## PLANNING & ZONING COMMISSION REGULAR MEETING TUESDAY, JUNE 4, 2024 - 3:30 PM MCALLEN CITY HALL, 1300 HOUSTON AVENUE CITY COMMISSION CHAMBERS, 3<sup>RD</sup> FLOOR

- a) Triple "B" Mobile Park II Subdivision, 10505 North 10th Street, FWW Inc. (SUB2024-0055) (PRELIMINARY) BDE
- b) Jain at Freddy Subdivision, 1001 Freddy Gonzalez Road, Nanak, Ltd. (SUB2024-0058) (PRELIMINARY) SEC
- c) Plantation Oaks North Lots 10A & 10B Subdivision, 12801 North Taylor Road, 5 A Construction, LLC (SUB2024-0057) (PRELIMINARY) INCD
- d) Las Nubes at Taylor Subdivision, 1301 South Taylor Road, ALPEG Properties, LLC (SUB2024-0060) (PRELIMINARY) M2E

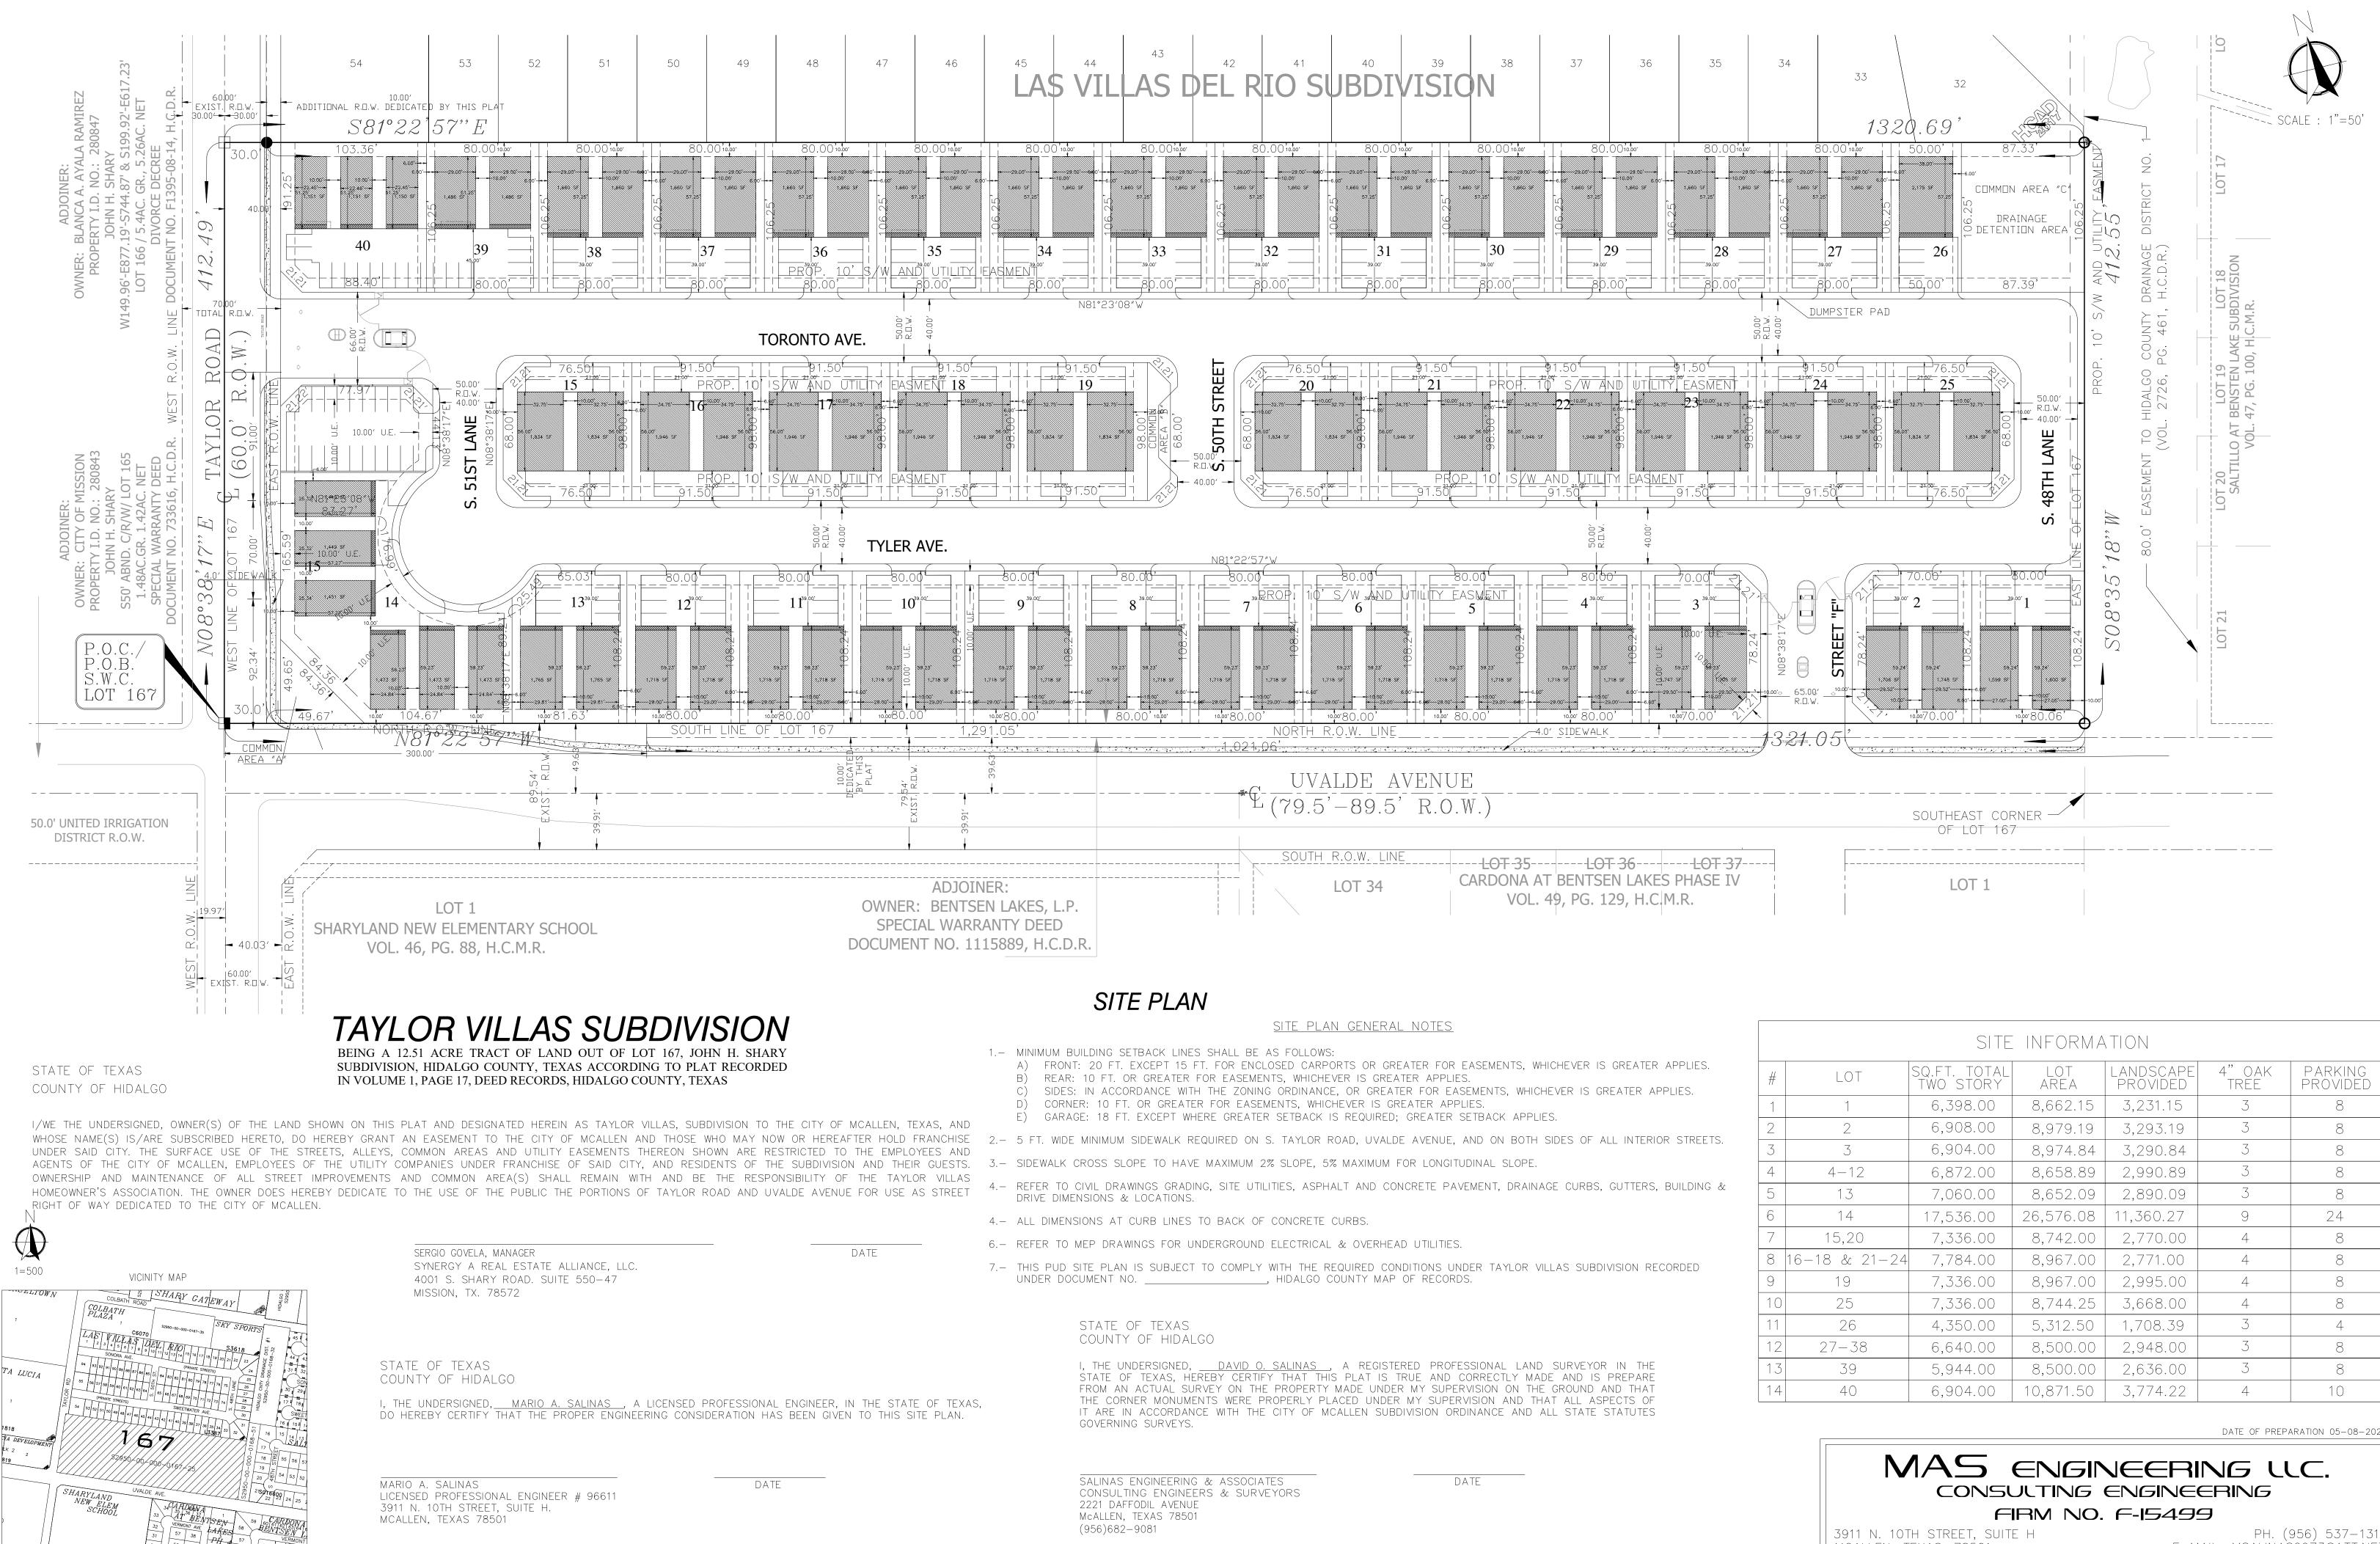
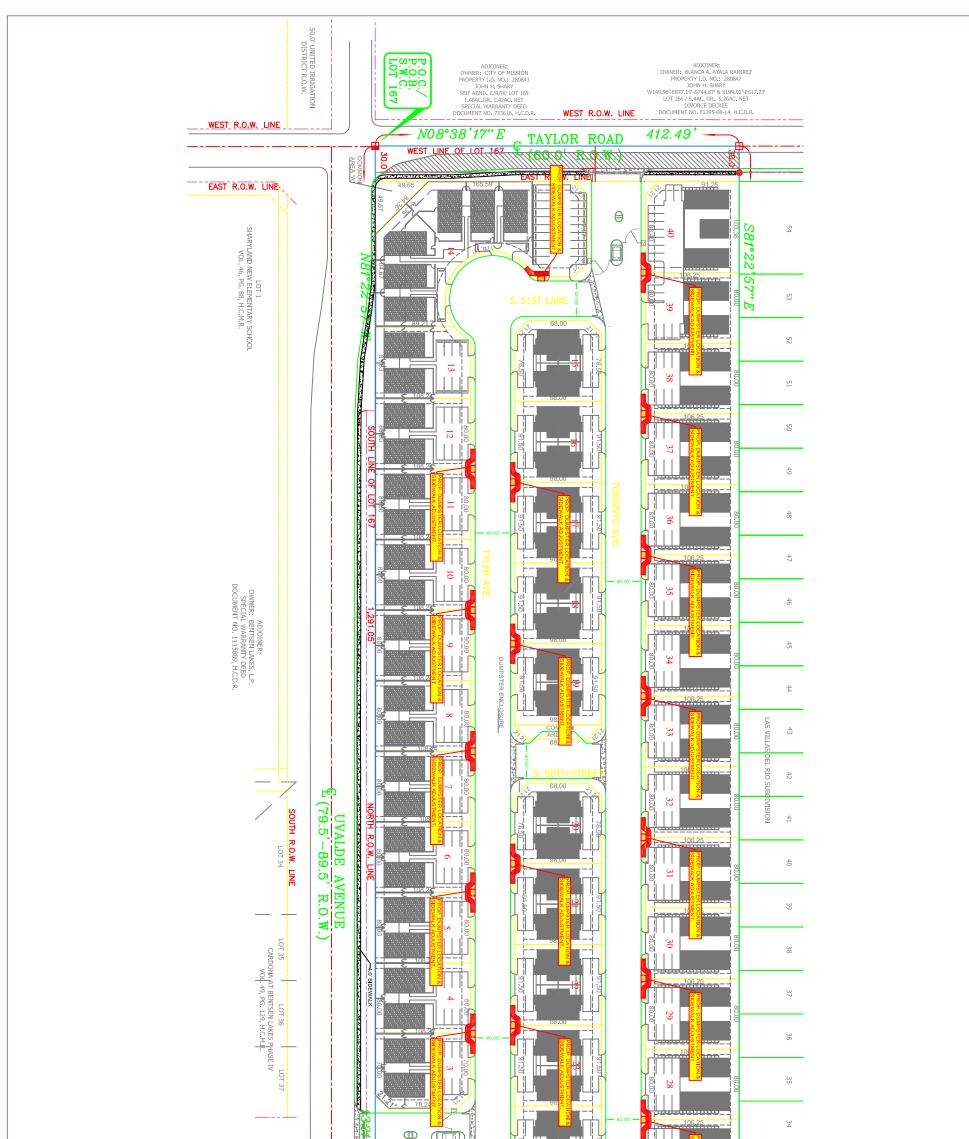
- 1. <u>CONCEPTUAL SITE PLAN:</u> Development and use of the property must comply with the conditional use permit conceptual site plan.
- 2. <u>PERMITTED USES</u>: Proposed uses are uses permitted in the R-3A (multi-family apartment residential) District for detached buildings designated as apartments.

- 3. <u>OFF-STREET PARKING AND LOADING:</u> Parking in compliance with Chapter 134 Article VII, Section 138-395 (1) (b.). Triplex, fourplex, apartment/condominium buildings with five or more units: Two parking spaces for each two or more bedrooms living unit. Based on the 168 living units, 334 total parking spaces are proposed, with 4 parking spaces for Lot 26, 8 parking spaces required for Lots 1-13, 15, 20, 16-18, 21-24, 19, 25, 27-39, 24 parking spaces required for Lot 14 and 10 parking spaces for Lot 40. The overall site plan is complying with parking requirements.

- 5. <u>STREETS AND SETBACKS</u>: Final setbacks and right-of-way dedication will be addressed and determined through the subdivision review process.
- 6. <u>DRAINAGE</u>: Addressed through subdivision process. Final drainage detention and design and the drainage plan must be submitted and in accordance with City of McAllen Standard Design Guide.

- 8. Owner, Engineer and Surveyor certification and signature block needs to be shown on the PUD site plan. Submitted site plan meets requirements.
- 9. A recorded subdivision plat and PUD site plan is required prior to issuance of building permits. The subdivision review process must be completed, and the subdivision plat must be recorded together with the PUD site plan.

**OTHER PUD SITE PLAN CONSIDERATIONS:** Three different elevation plan types will be recorded along with the PUD site plan that will reflect three different lot groups (i.e., Lots 1-16, Lots 17-27, and Lots 29-42).

# PROPOSED SITE PLAN FOR CLUB ADDITION AMENDED LOT 2A

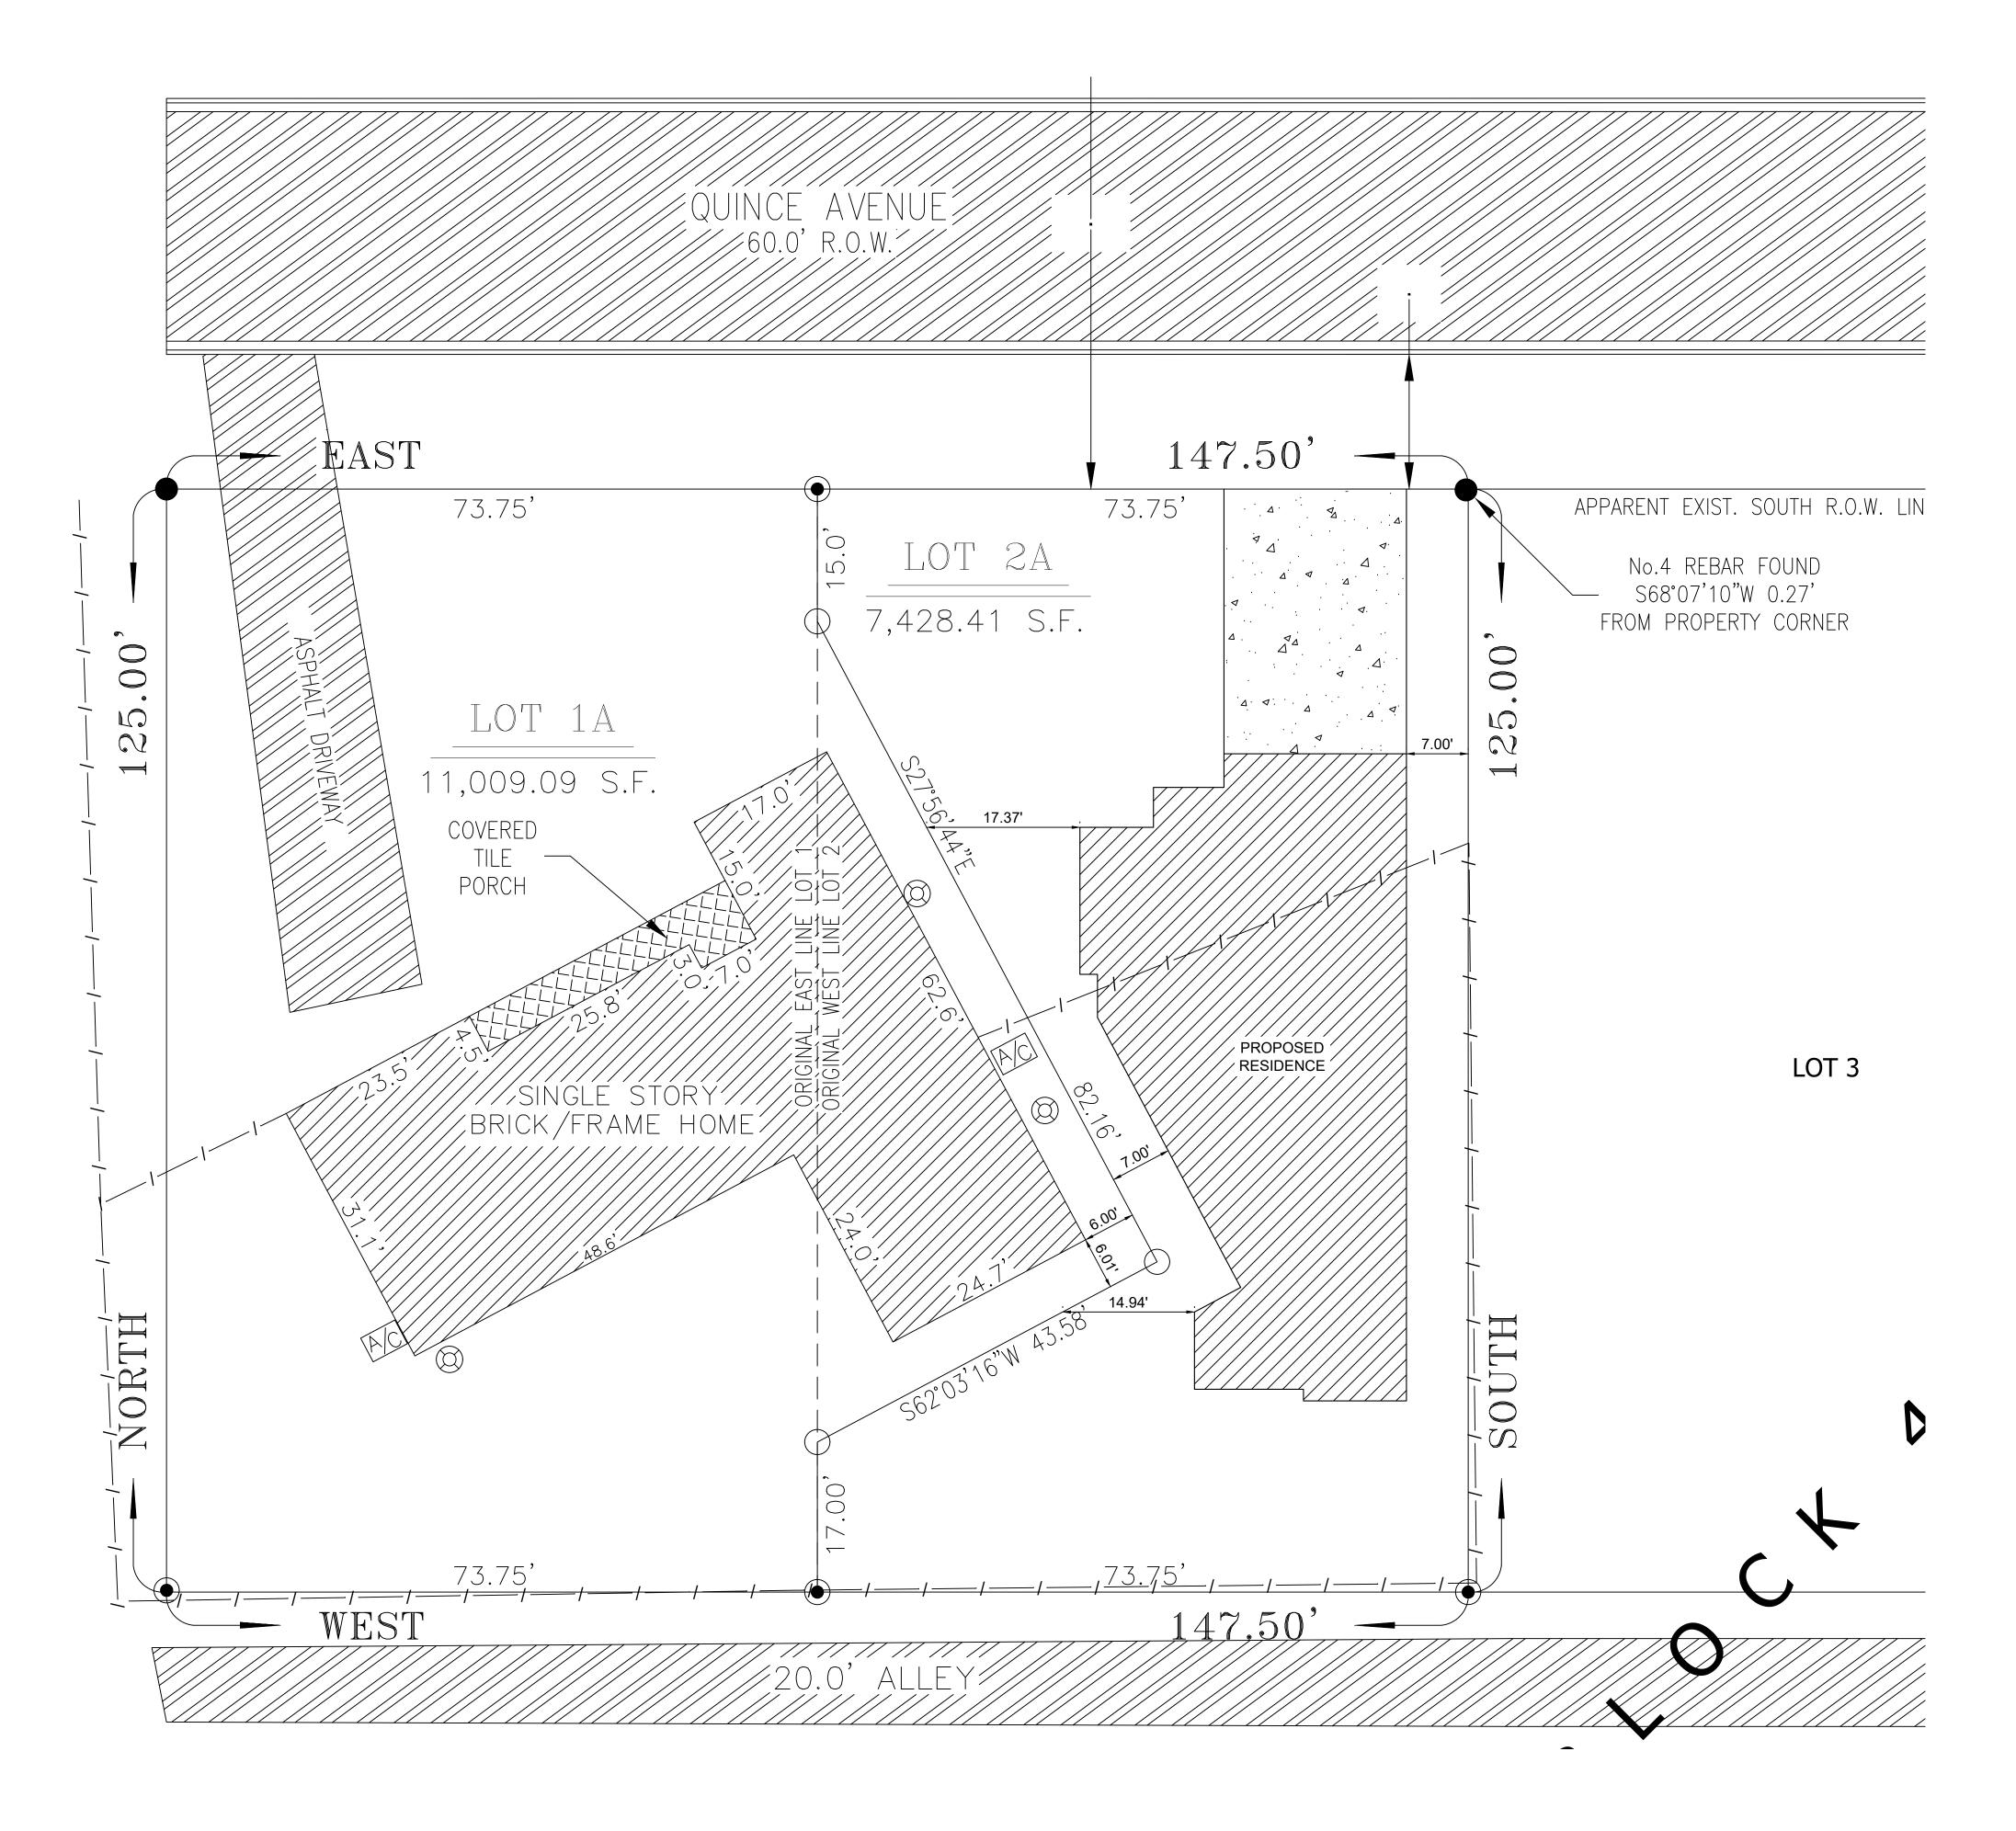
SUBDIVISION NAME: CLUB ADDITION	
REQUIREMENTS	
STREETS AND RIGHT-OF-WAYS	
<ul> <li>Quince Avenue: Dedication for 25 ft. from centerline for 50 ft. total ROW.</li> <li>Paving: 32 ft. Curb &amp; gutter: Both Sides</li> <li>Revisions Needed:</li> <li>Provide ROW details, as to ensure compliance with minimum requirements as noted above prior to final.</li> <li>Reference the document number on the plat for the existing ROW, adjacent to the subdivision boundary, and provide a copy for staff review as applicable prior to final.</li> <li>**Subdivision Ordinance: Section 134-105 and/or COM Thoroughfare Plan</li> <li>***Monies must be escrowed if improvements are required prior to recording.</li> </ul>	Non-compliance
<ul> <li>North 1 1/2 Street: Existing 30ft. of total ROW per recorded plat.</li> <li>Paving :32 ft. Curb &amp; gutter: Both Sides</li> <li>Revisions Needed: <ul> <li>Engineer must clarify and reference existing dedications on plat, ROW requirements will have to be reviewed once existing dedications have been established. Finalize ROW requirements for Original 1 1/2 Street, subdivision, paving, ROW, and note requirements subject to change once ROW is clarified, prior to final.</li> <li>Provide ROW details and reference the document number on the plat for the existing ROW, and provide a copy for staff review as applicable prior to final.</li> <li>Any abandonments must be done by separate process, not by plat.</li> </ul> </li> <li>**Subdivision Ordinance: Section 134-105 and/or COM Thoroughfare Plan</li> <li>***Monies must be escrowed if improvements are required prior to recording.</li> </ul>	Non-compliance

* Sides: In accordance with the zoning ordinance or greater for easements, whichever is greater applies. **Zoning Ordinance: Section 138-356	Applied
* Corner: 10 ft. or greater for easements.	Non-compliance
Revisions Needed: -Note requirement under review, as survey and original subdivision plat exhibit ROW along the western boundary of lot 1, clarify existing dedications, any existing abandonments must be referenced on plat, finalize corner setbacks requirements prior to final. **Zoning Ordinance: Section 138-356

- Public Hearing with notices will be required for the re-subdivision.	
<ul> <li>Revise name of Subdivision to "Club Addition Amended Lots 1A and 2A Subdivision"</li> <li>Remove reference to pavement/curb &amp; gutter as only ROW should be shown. Also, remove house footprint from plat.</li> </ul>	
RECOMMENDATION	
	A
Recommendation: Subdivision was approved in preliminary form subject to the conditions noted, drainage and utility approvals at the Planning and Zoning Commission meeting of December 19, 2023.	Applied
